Re: EB-2021-0110 – Hydro One Networks

HYDRO ONE NETWORKS Inc.

Joint Custom IR Distribution and Transmission Application (2023-2027)

POWER WORKERS' UNION INTERROGATORIES

Ref 2: Exhibit B-2-1 Section 2.3 Page 4 of 8

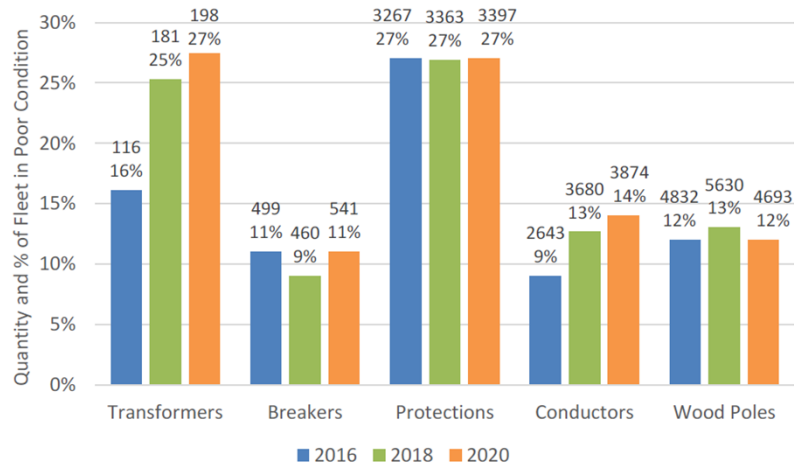
- a) Ref 1 indicates that Hydro One plans to replace 2.7% of the wood pole fleet per year whereas Ref 2 states Hydro One plans to replace 2.9% of its poles per year over the next five years. Please explain the discrepancy.
- b) For each asset category listed in Ref 1, provide a chart that shows the number and share (%) in total asset that are in poor condition, inadequate performance and obsolete. For guidance, please use a chart similar to the following:

Figure 9 – Average Age of Distribution Wood Poles

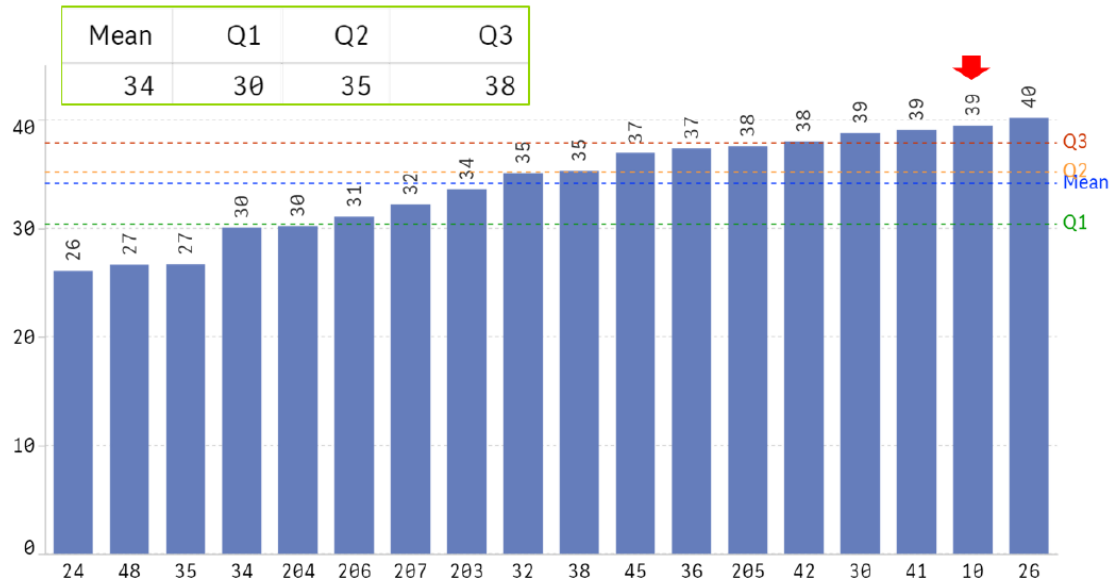
- f) How many of Hydro One’s wood poles are both: (i) above the ESL of 47 years; and (ii) categorized as being in better than “poor” condition?
- g) Given that the average age of HONI’s poles is the second highest within the comparison panel at 39 years (Ref (3)), compared to the group average of 34 years, does Hydro One believe its proposed rate of replacement would be enough to address the concern cited in Ref (4) in regard to the gap between the ESL for poles and the current replacement rates by the industry?
